To, **HUNTER AND CENTRAL COAST REGIONAL PLANNING PANEL**

In regard to deferred submission (for DA49578/2016 at 321 Mann Street Gosford, Lots 8, 9, 10 & 11, Sec 1, DP 1591 and Lot: 12 SEC: 1 DP: 1591 Lot: 13 SEC: 1 DP: 1591 331 Mann Street Gosford NSW –Commercial & Shop Top Housing (JRPP)) this cover letter addresses the panel recommendations that need to be carried out. Each point given from the panel, has been seriously treated and addressed, hence we strongly believe that the below modifications meet your expectations.

Fig.1 Waste Management. Ground Floor section.

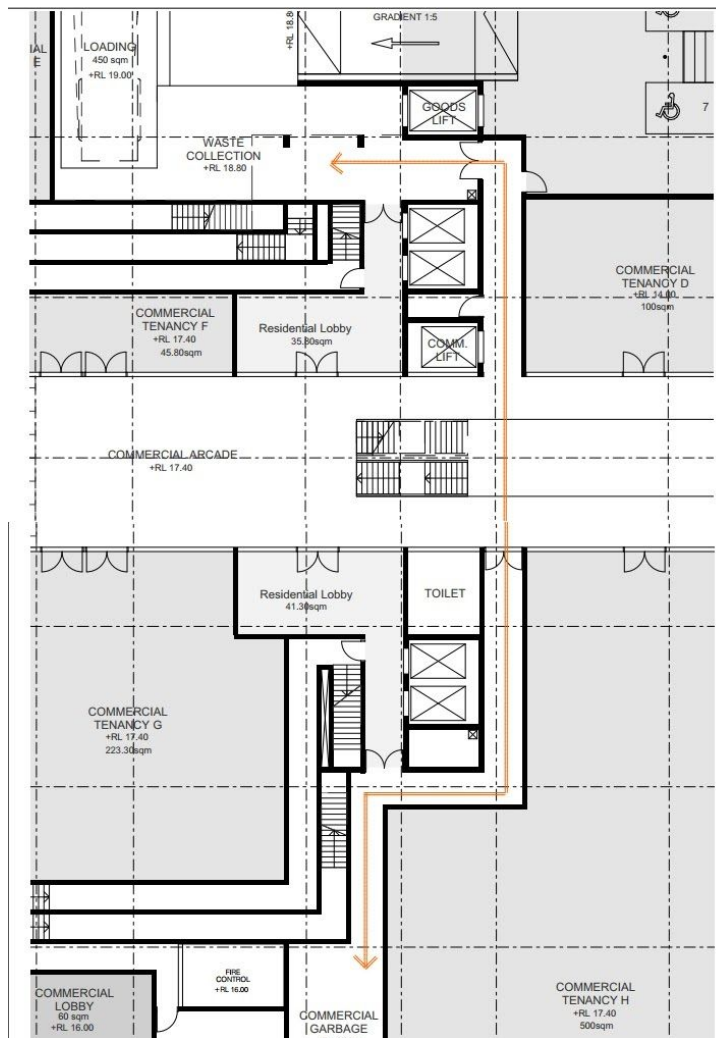
- RE 7.: Another additional issue addressed is waste management. As on the initial plans, the Commercial waste bulk bin to be transferred through the Residential Lobbies on the ground floor, with the new proposal of making an alternative route, such a problem is solved. (as shown in the Fig.1 next page).
